ADDENDUM NO. 01

September 23, 2026

**WARREN COUNTY CAREER CENTER
MEDICAL ACADEMY ADDITION
3525 NORTH STATE ROUTE 48
LEBANON, OHIO 45036**

LPA PROJECT NO. 263306.00

S101

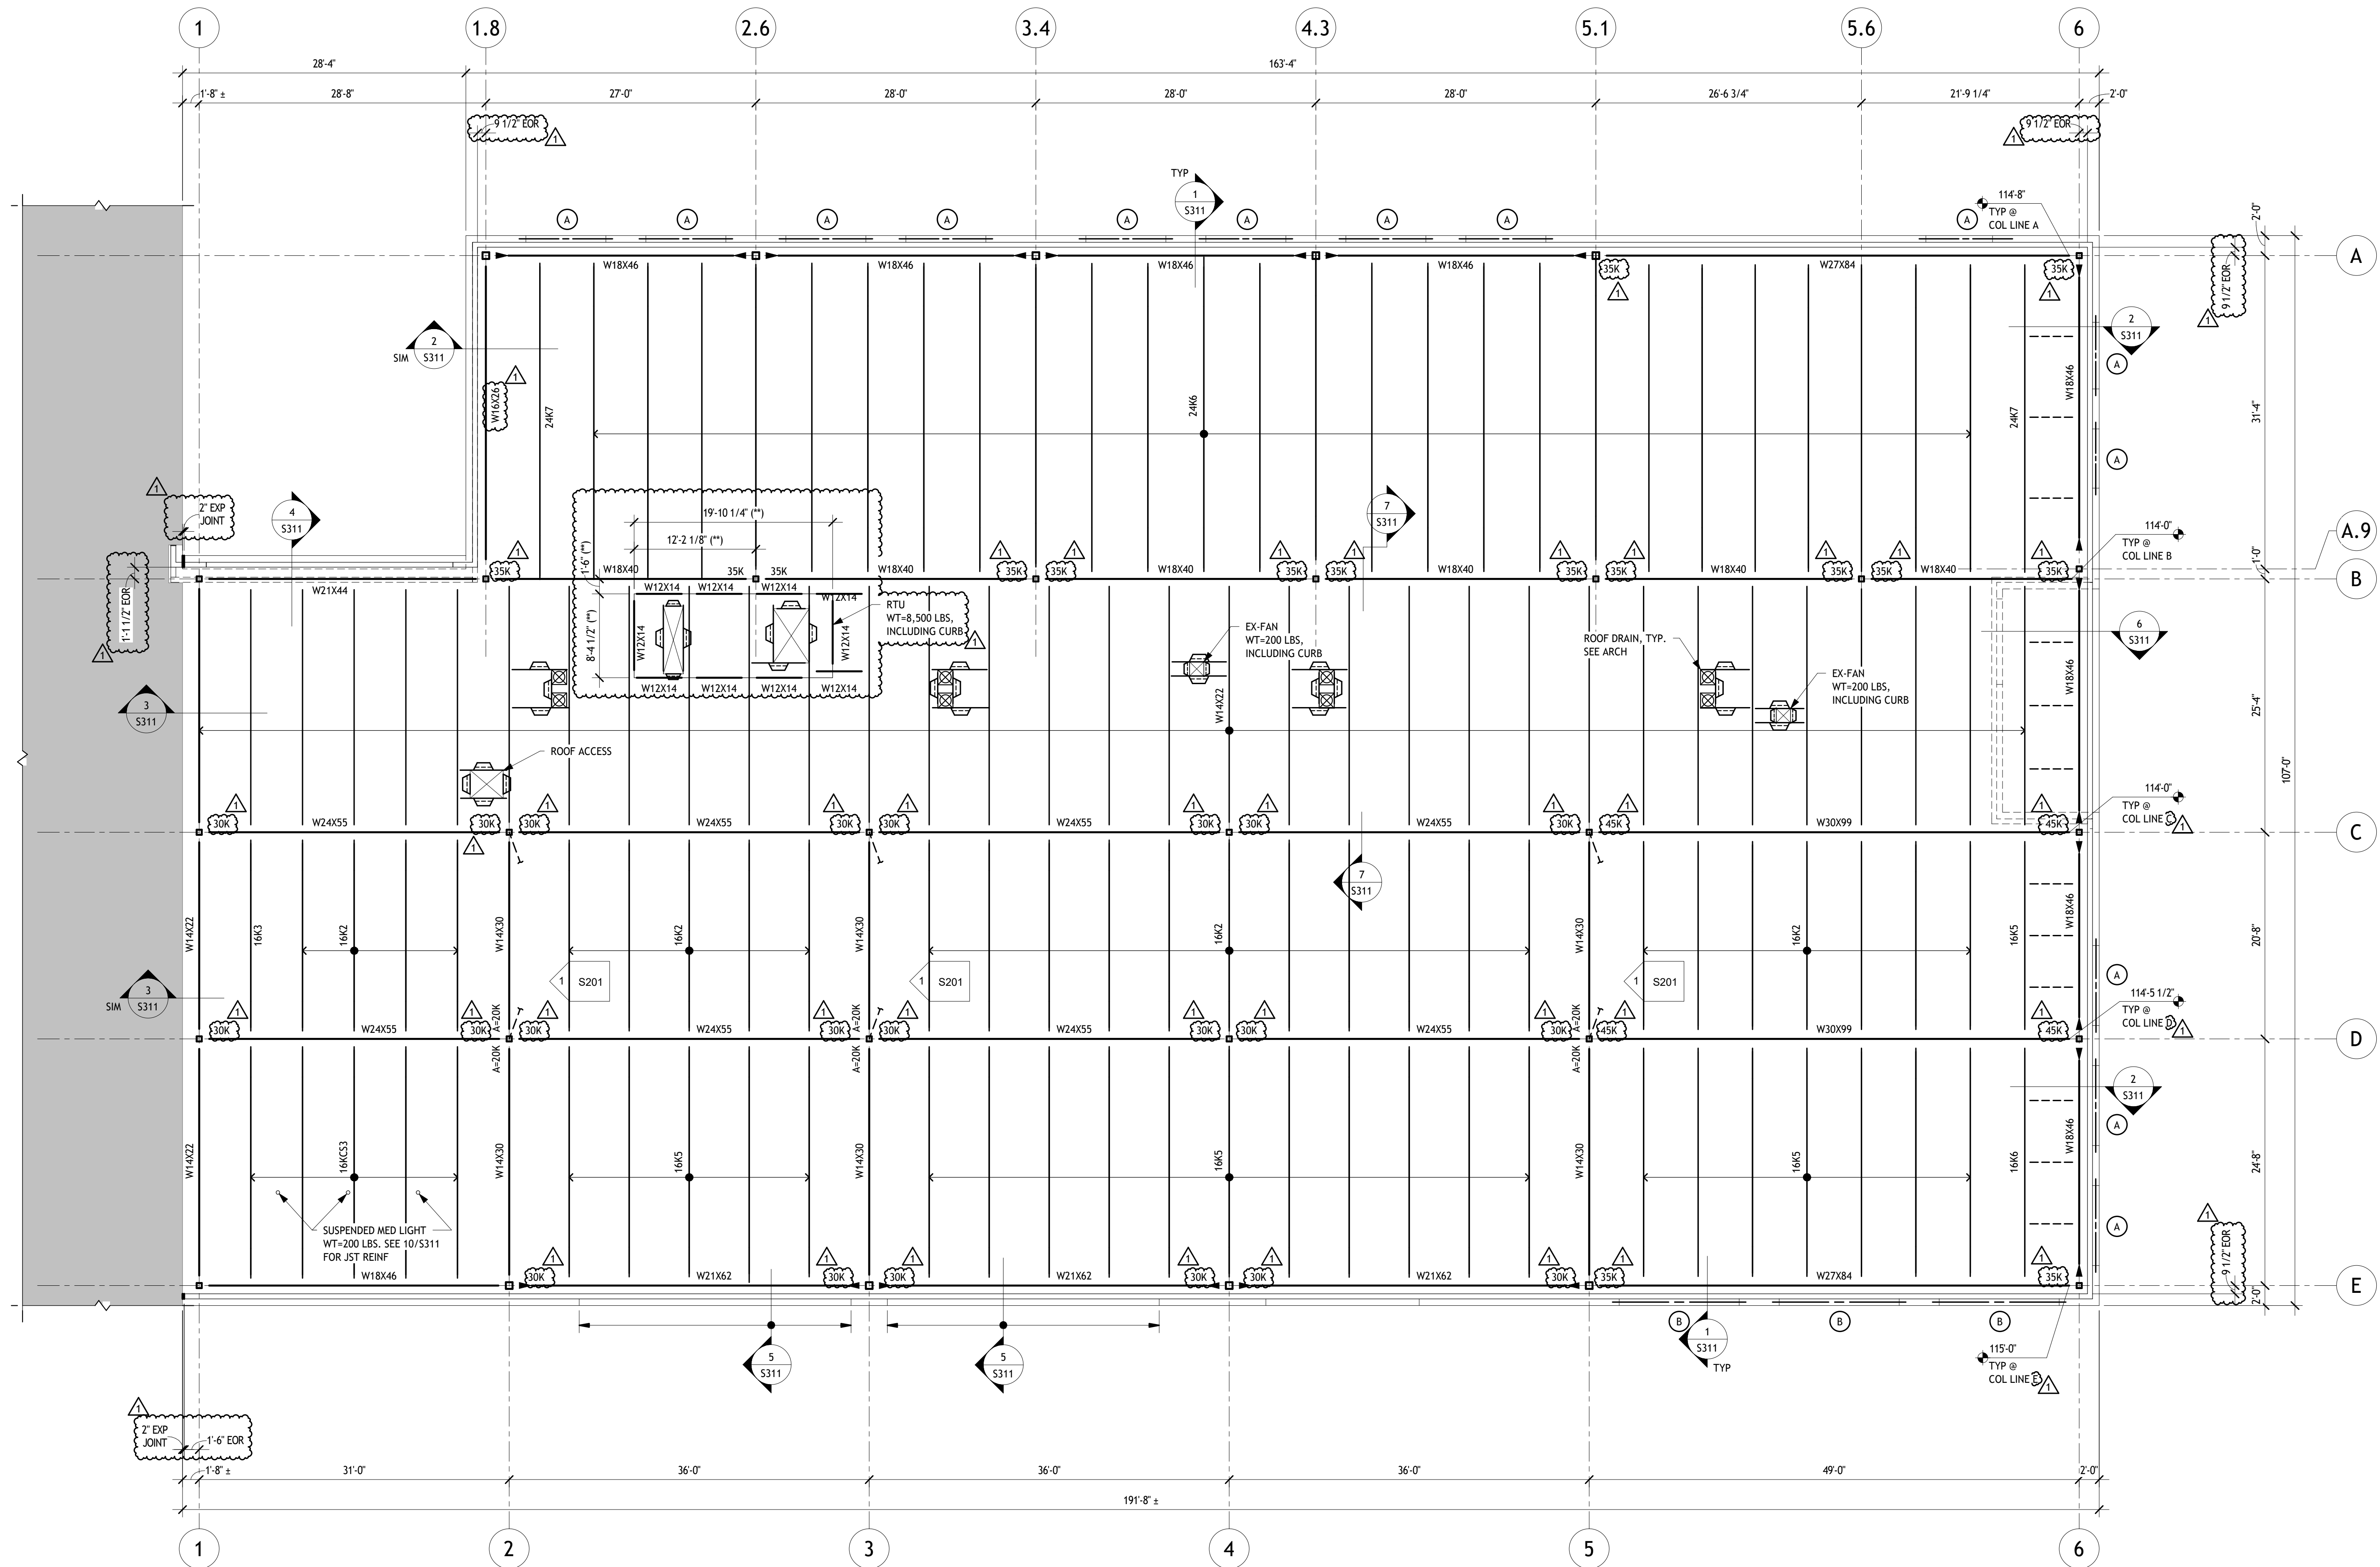
2.9 Sheet S101

- Updated foundation plan notes to include geotechnical report information.
- Updated typical top of footing elevation in foundation plan notes.
- Fix detail reference callout in foundation plan notes.
- Updated piers to P4 at E1, B1, and B1.8.
- Updated P3 top of pier elevation.
- Updated foundation elevation for underground utilities at entrance.

26 ROOF PLAN
SCALE | 1/8" = 1'-0"

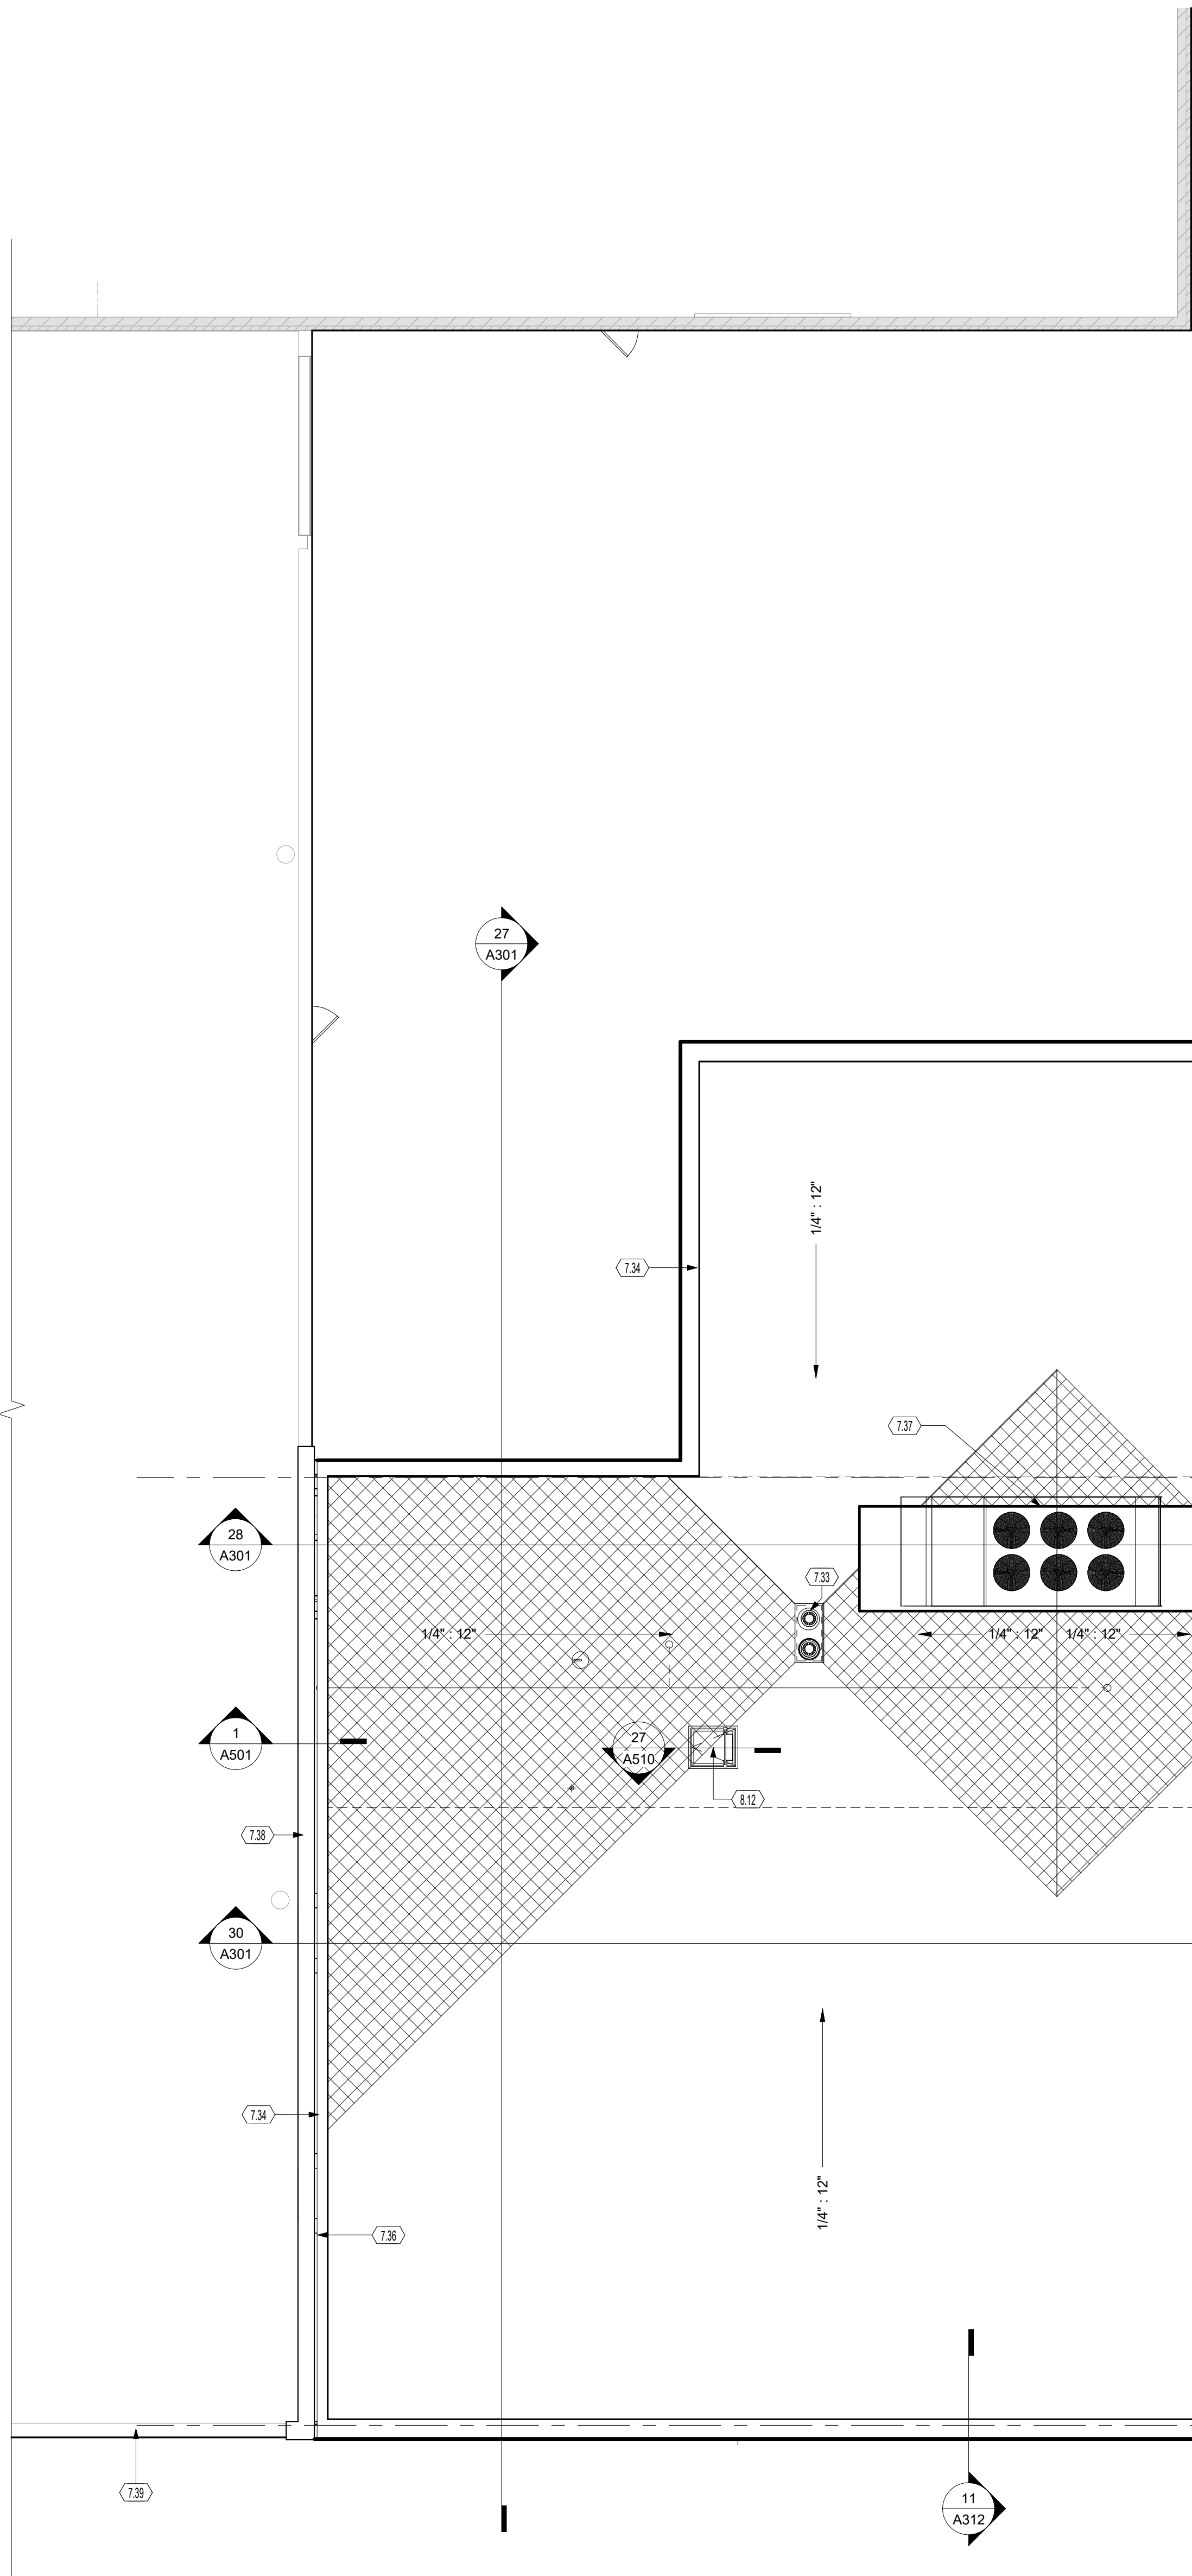
- 2.22 Sheet A411- Interior Elevations
- Updated interior elevation 29C to show the tall storage cabinets eliminated.
- 2.23 Sheet A141 Roof Plan
- Updated roof access ladder detail to be painted steel

19 RAMP SECTION
SCALE | 1/2" = 1'-0"

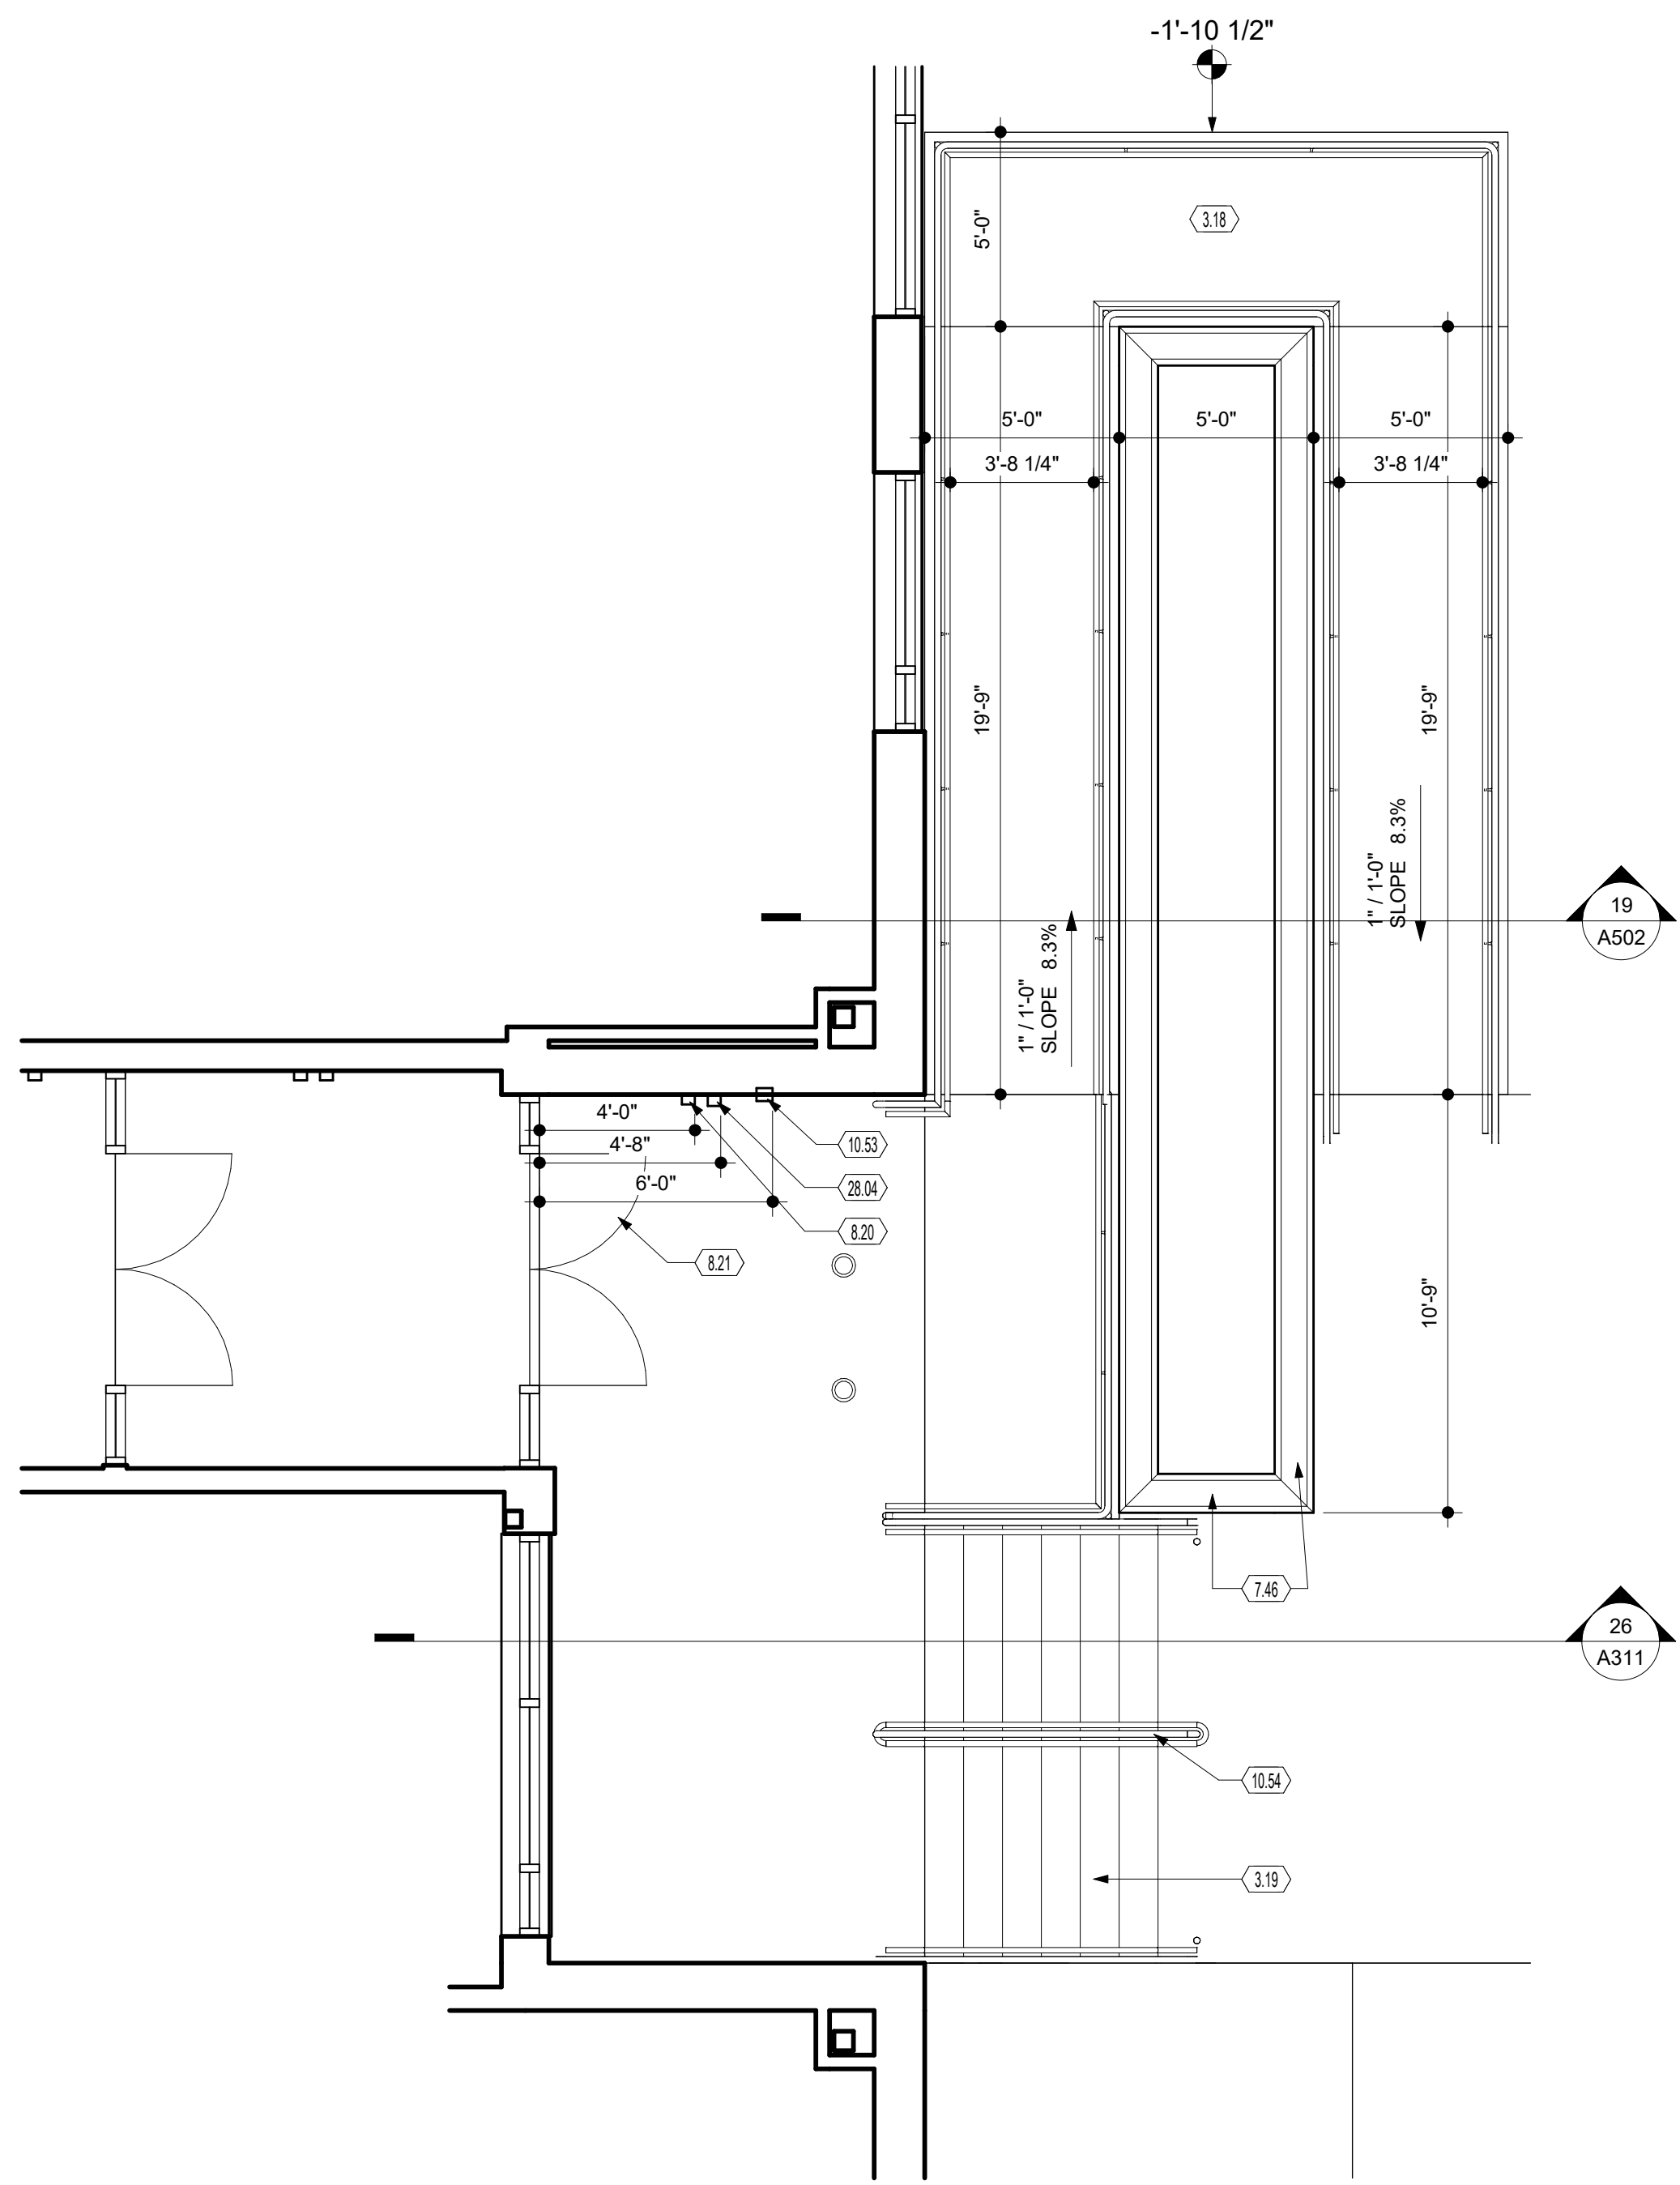
- 2.4 Reference: Sheet A311, WALL SECTIONS
 - Updated Keynote 10.54 to indicate Anodized aluminum handrail.
- 2.5 Reference: Sheet A502, EXTERIOR DETAILS

- Updated Ramp Section to match structural Details.
 - Revised Keynote to indicate Anodized Aluminum Handrails
- 2.6 Reference: Sheet A121, REFLECTED CEILING PLAN

- 3.1 There are two different materials called for the building entrance railings. Sheet A311 calls for Stainless Steel for the railings. Sheet A502 note 10.54 calls out aluminum railing. Please clarify what material is to be used.
 - The railings should be anodized aluminum railings as indicated on sheet A502 note 10.54
- 3.2 Detail 2 on sheet A141 calls out the ladder to be steel but detail 3 calls out the ladder to be aluminum. The specs call for the ladder to be aluminum. Please confirm.
 - The interior Ladder access the Roof hatch should be painted steel.
- 3.3 Oldcastle Building Envelope and W.A. Wilson are approved Glass Fabricators.
- 3.4 Disregard Laminated Glass, and Decorative Plastic Film on section 08 80 00
- 3.5 Engineering calculations are not required for the storefront system per section 08 43 13
